ORIGINATION FORM -

Proposed Revisions to a Standard Plans Index (Please provide all information — Incomplete forms will be returned)

Contact Information:		Standard Plans:
Date: N	Лау 26, 2020	Index Number: 102-628
Originate	or: Derwood Sheppard	Sheet Number (s): 1
Phone:	(850) 414-4334	Index Title: Two-Way Left Turn Lane Closure
Email: derwood.sheppard@dot.state.fl.us		
Summary of the changes:

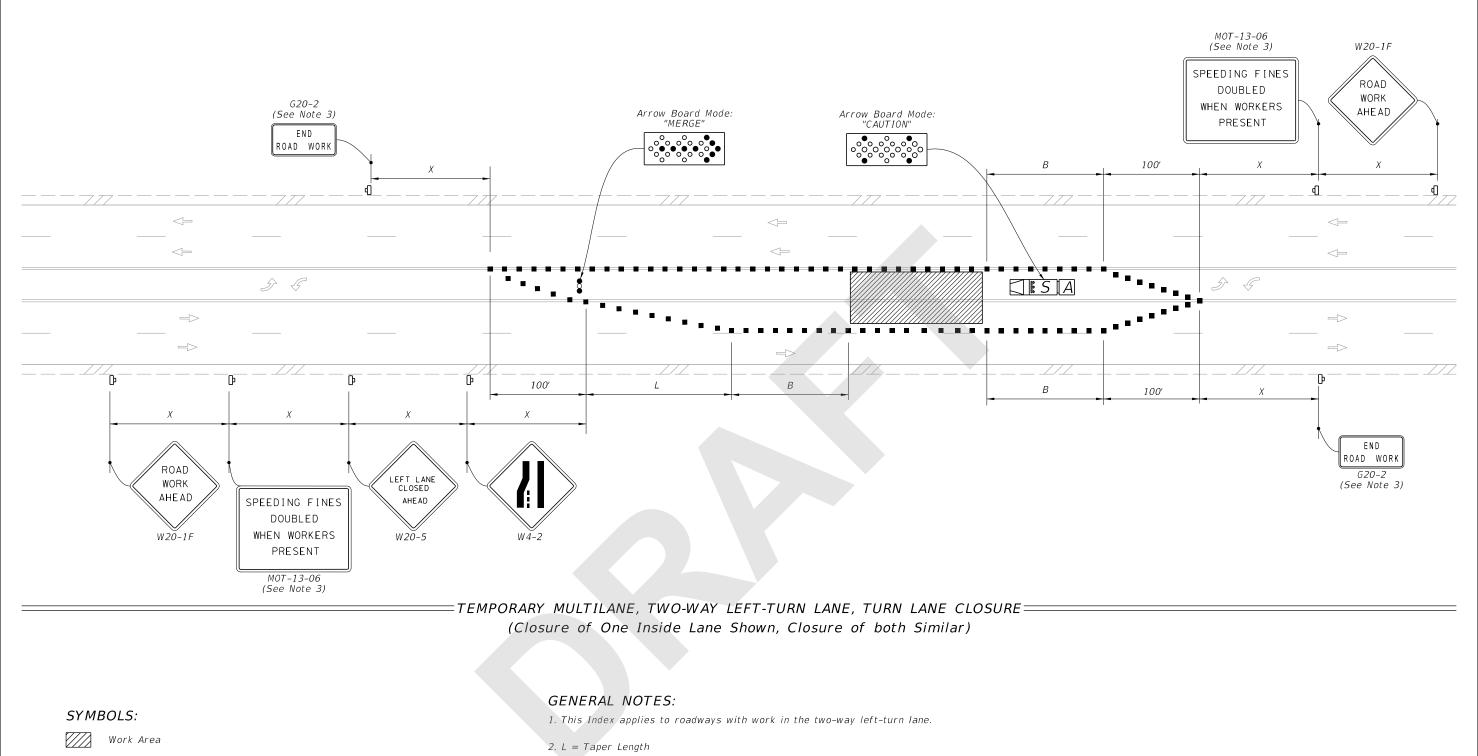
Sheet 1: Revised Detail to include closure of one Through Lane and turn-lane on a multi-lane roadway and Notes; Deleted Conditions; Updated Symbols. Sheet 2: Added option for "Work Within the Traveled Way" of a Two-Lane Roadway using a flagger. Sheet 3: Added option for "Work Within the Traveled Way" of a Two-Lane Roadway using the turn-lane as a		
Commentary / Background:		
Other Affected Offices / Documents: (Provide name of person contacted)		
	No Other Standard Plans — FDOT Design Manual — Basis of Estimates Manual — Standard Specifications — Approved Product List — Construction — Maintenance —	
(Email o	ration Package Includes: or hand deliver package to Rick Jenkins) N/A Redline Mark-ups Proposed Standard Plan Instruction (SPI) Revised SPI Other Support Documents	Implementation: ☐ Design Bulletin (Interim) ☐ DCE Memo ☐ Program Mgmt. Bulletin ☑ FY-Standard Plans (Next Release)
Contact the Roadway Design Office for assistance in completing this form
